*LUCAS COUNTY
PLAN COMMISSION
REPORT*

August 24, 2016

1. Z20-C983: Conditional Use Permit for Semi-Public Use in A-4 district at 2728 N. King Road (bh)

2. S-12-16: Preliminary Drawing Review of FIELDBROOK ADDITION, located south of Bancroft Street, east of King Road (bh)

SITE PLAN

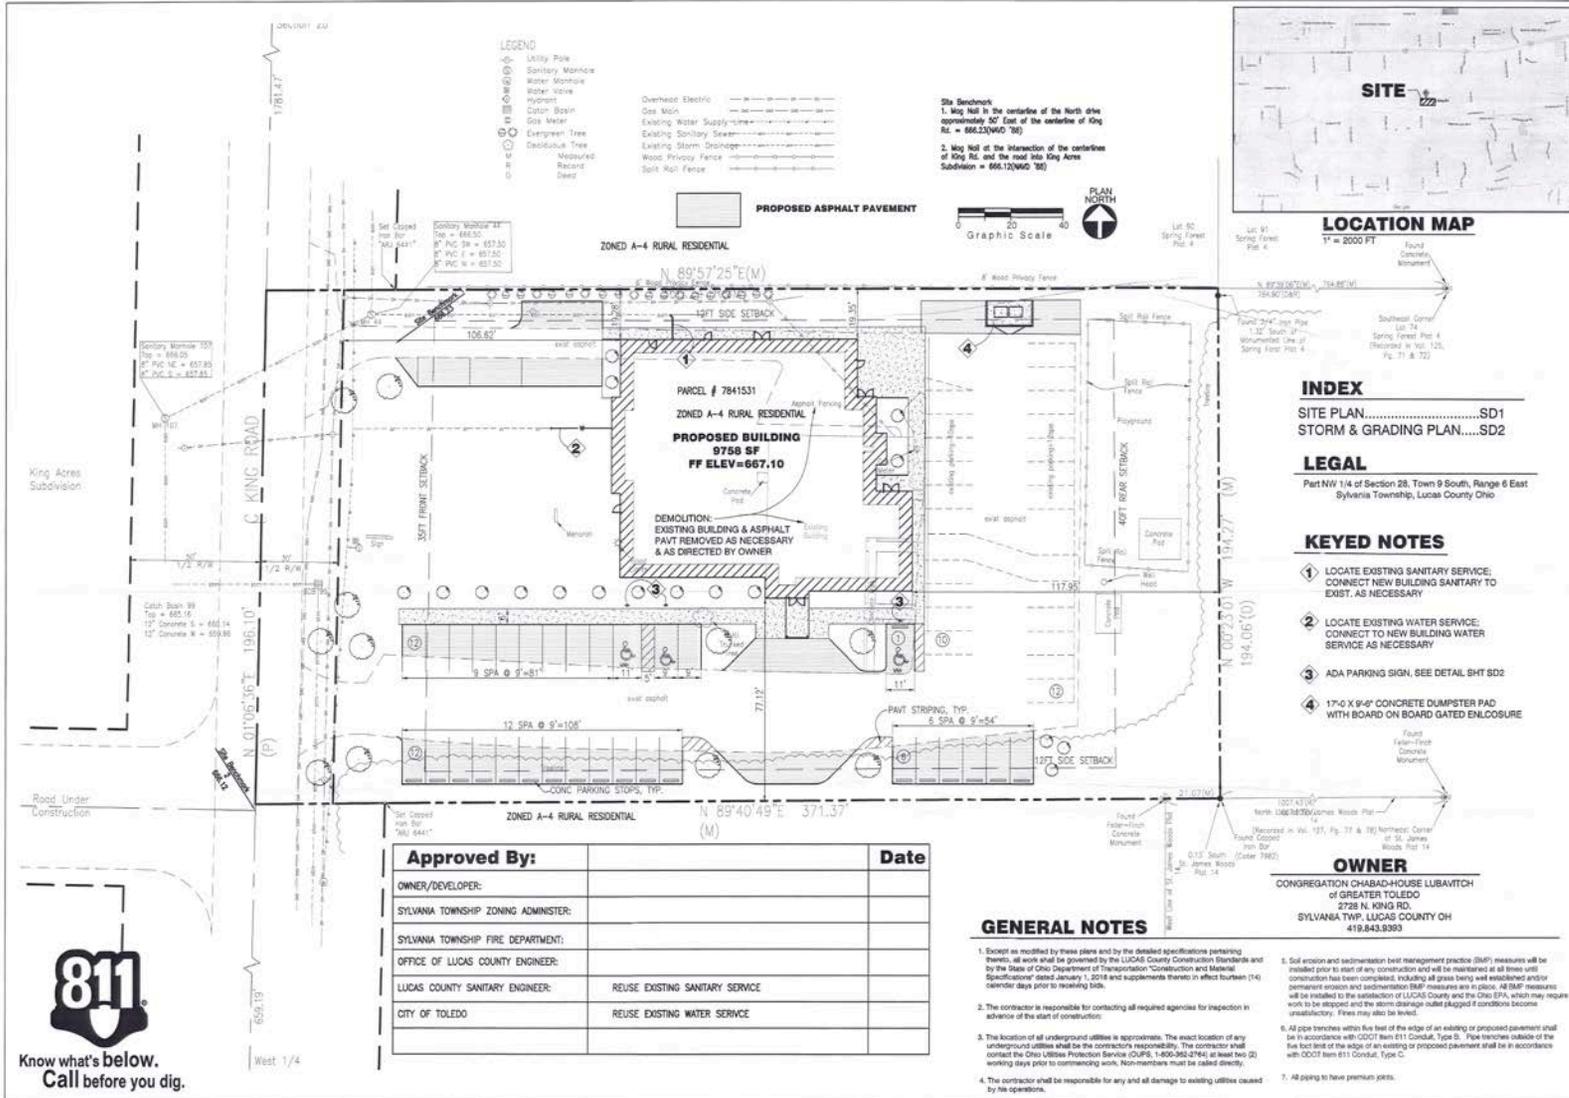
1. Water is available to the site via W-1671-12" on the east side of King Road. This main shall be labeled as such.
2. LCSE has no records that there is an existing water service to this property as shown on the plans. The City of Toledo will perform all taps into the county water main at the expense of the contractor. This shall be stated on the plans.

3. All water service connection points, size of service, lengths, material, bends, etc. shall be labeled on the plans.
4. Sanitary sewer service is available via S-904-8" on the east side of King Road. This main shall be labeled as such.

5. There is only a 10' stub of 6" protruding from manhole #44. The existing sanitary sewer on the north side of the lot currently does not exist and will need to be installed.

6. Elevations of the sanitary sewer at the connection point, at all fittings, and at the cleanout shall be labeled.
7. The sanitary sewer service shall be inspected by a LCSE representative and all inspection fees shall be the responsibility of the owner/developer.

13. Section 2914 of the Sylvania Township Zoning Resolution requires one (1) parking space per five (5) seats for a place of worship. The total number of parking spaces required as well as the total number of parking spaces provided need to be indicated on the site plan.

14. The width of the access drives is not shown. Section 2902 requires a minimum of twenty feet (20') width.

15. Sylvania Township requires all new developments or redevelopments to have sidewalks along the street frontage of the property. The site plan shall indicate the location and width of the sidewalk.

16. The distance of the parking areas from the abutting residential boundaries should be indicated. There is no minimum requirement for this for a semi-public use, but commercial/industrial uses are required to have at least a five foot (5') setback. It is probable that the BZA will set at least that distance as a condition to the Conditional Use.

17. The distance from the proposed building to the centerline of King Road needs to be indicated.

18. Section 2222 dictates a 100' building setback from King Road. This appears to be met, but should be indicated on the site plan.

19. An eight foot (8') privacy fence is shown along the northeast boundary of the property. The maximum allowed fence height in a residential zone is six feet (6').

21. The names, addresses, and zoning classification of abutting properties shall be indicated on the site plan.
22. The dimensions of the dumpster enclosure shall be indicated on the site plan.

25. The proposed site development is considered a redevelopment and an access permit application shall be submitted to the Lucas County Engineer's Office. The existing two driveways are being changed from one way enter and one way exit to two full access driveways. The required spacing is not met for two full access driveways and therefore the northerly driveway should be removed or a variance will be required from the access appeal board.

26. Submit storm drainage calculations for review and approval. An internal drainage system with storm water detention to limit peak discharges to "pre-developed" conditions may be required.

28. The required front yard setback per the township zoning resolution is 100 feet from the centerline of King Rd.
29. Indicate driveway radii on the plan. The driveway is being changed from a one way enter to a full access driveway and minimum radii of 25 feet are required.

- a. Number of parking spaces required and provided.
- b. Label the names of abutting property owners on the plan and abutting zoning for parcel to the east.
- b. Site Location Map street names are not very legible. Show closest Public Street to north (Finchwood Lane).
- c. Van accessible spaces should have eight (8) foot marked access aisle and an 8 foot parking space.
- d. Label existing and proposed parking drive aisle dimensions.
- e. Adjacent road across the street has now been platted and is called King Acres Drive.

32. All proposed pavement elevations, grading and swales along the adjacent property lines shall be labeled with proposed slopes, proposed spot elevations, and existing spot elevations along the property lines.

33. Elevations indicate a low spot in the pavement along the south driveway. A catch basin or other design change may be needed to avoid standing water.

34. Pavement Details: Item 448 is now Item 441 in the current ODOT CMS with a (448) designation.

35. Label the pipe size for the existing 12 inch storm sewer running under the southerly driveway. Existing plans indicate that the pipe ends 70 feet south of the catch basin and just south of the driveway.

PRELIMINARY PLAT AND PLANNED UNIT DEVELOPMENT PLAN FIELDBROOK ADDITION

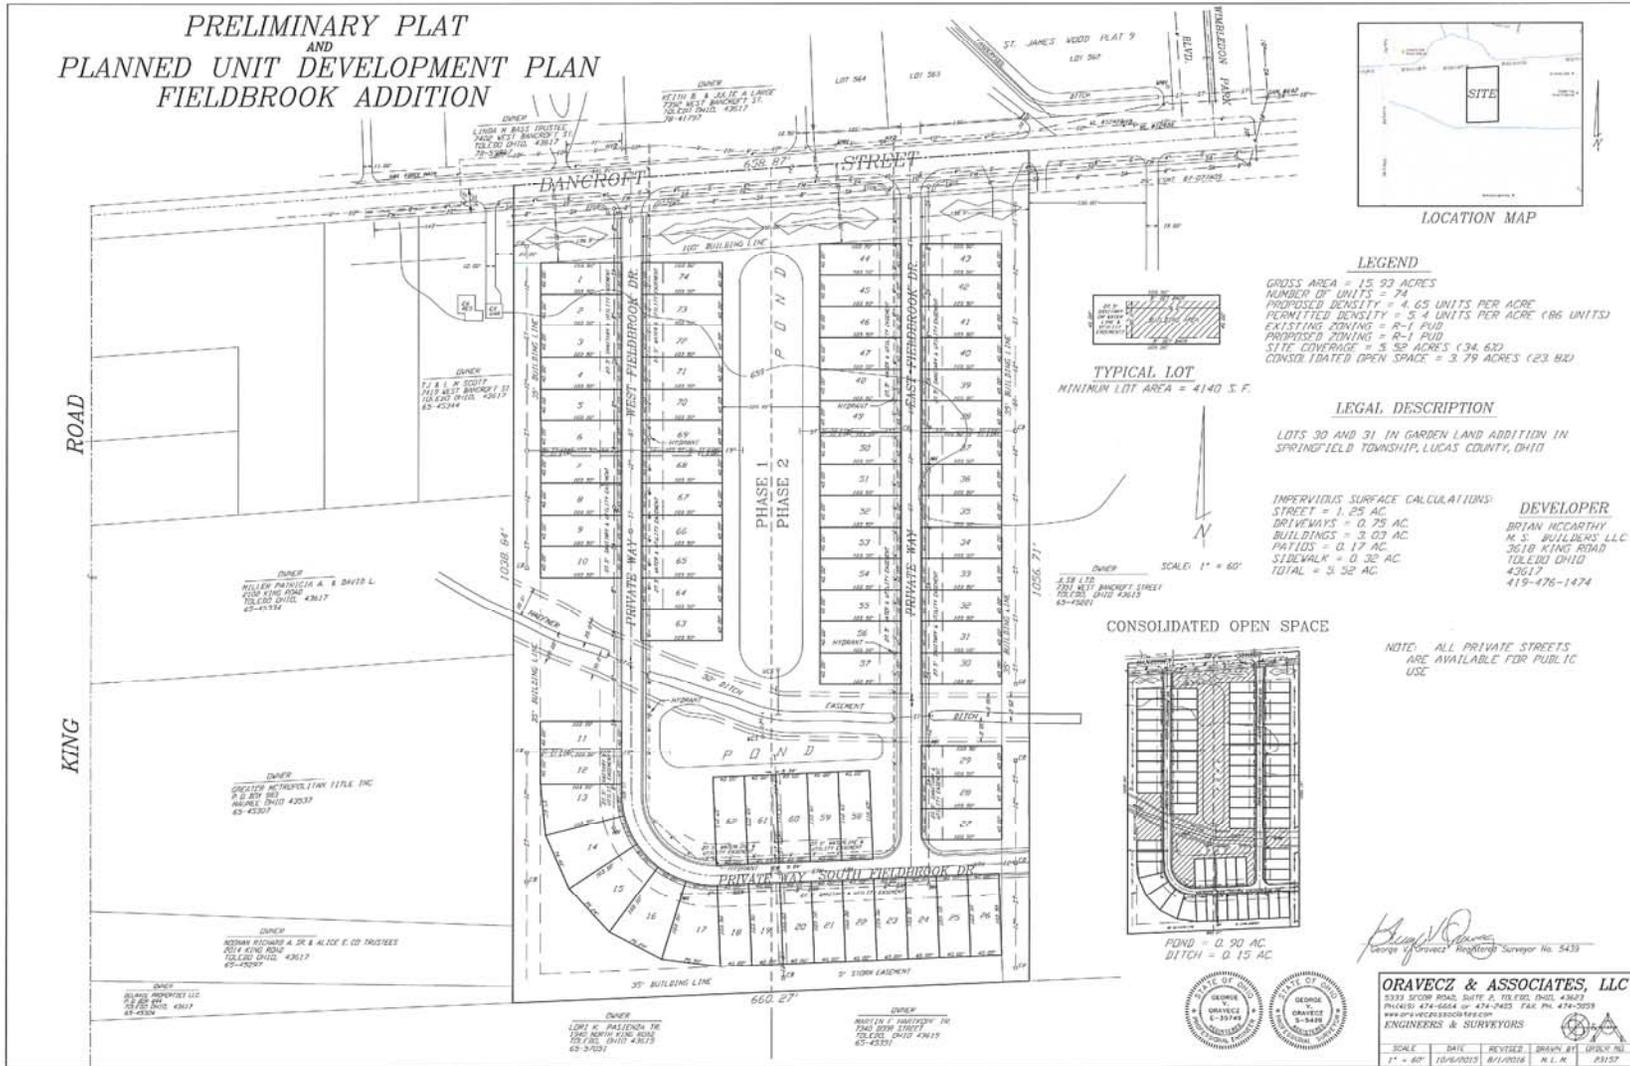
1. The owner, address, & parcel number should be located on each proposed developed, parcel.
2. Water is available to this site via W-1248A-10" on Bancroft Street for parcel 65-45248 and via W-1473-10" on Bancroft Street for parcel 65-45271. The aforementioned waterlines shall be called out as such.

3. The watermain in the subdivision shall be clearly labeled as "PRIVATE". The point of connection at any "PUBLIC" watermain shall be labeled clearly, "BEGIN PRIVATE WATERMAIN".

4. All watermain connections to the "PUBLIC" system shall include a check valve at all connection points. A "Private" valve in a manhole shall also be installed after the check valve.

6. The proposed 18" sanitary sewer on Bancroft Street shall be labeled as S-908-18".
7. The existing 10" force main on Bancroft Street shall be labeled as S-693-10". There is also an existing 4" force main on the North side of Bancroft Street. This force main shall be shown and labeled as S-213A-4".

10. The proposed 18” sanitary sewer will be in an easement. This easement shall be shown and labeled on the plat. LCSE will need a copy of this document prior to any construction taking place.

- 23. Sidewalk shall be constructed along Bancroft Street.
- 24. Detailed landscaping plan shall be submitted with buffering along all property lines.
- 25. Pedestrian/bike path shall be constructed.
- 26. Roads shall be built with public specifications.

29. If possible, West and East Fieldbrook Drives to be designed and constructed to support the imposed loads of fire apparatus and be all weather surfaced prior to vertical construction (OFC 503.2.3).
30. If construction of surfaced roads prior to construction is not possible, then an approved area for turning around fire apparatus shall be provided (OFC 503.2.5).

33. Rear yard catch basins, drainage swales and easements will be required in accordance with Lucas County Drainage Standards.
34. The construction plans shall provide for the installation of all interior street monuments. If not completed, a performance guarantee shall be provided for street monuments and all other monuments that are not a part of the construction plans.

35. Footer tile outlets shall be provided to all lots unless basements and crawls are prohibited by a plat recitation.
36. Right-of-way areas along Bancroft Street shall be graded to provide roadside ditch swales, storm drainage and adequate shoulder widths.

38. To provide improved traffic operations and access management, utilize one roadway connection to Bancroft Street rather than two. The proposed two roadways do not meet the required minimum spacing of 800 feet for new roads per Section 510, Table 3 of the Subdivision Regulations which refers to Appendix B-3 of the Access Regulations. We have been informed that the Springfield Township Trustees have taken a position on the PUD zoning approval that they would prefer two access points rather than just one. Therefore, for this particular case we have no objections to the variance in the access spacing.

40. A temporary turnaround shall be provided at the end of streets if the subdivision is developed in phases.
41. Provide 35 foot minimum uncurbed radii at the intersection of Bancroft Street and Fieldbrook Drive. Pavement grading on Fieldbrook Drive must direct storm runoff away from Coder Road.

43. In accordance with subdivision regulations, sidewalks shall be constructed along the street frontage in the subdivision, and along the south side of Bancroft Street.

44. The storm sewer mains shall be located within the proposed right of way. Rear yard swales and catch basins shall be provided on the lots in accordance with Lucas County Standards.
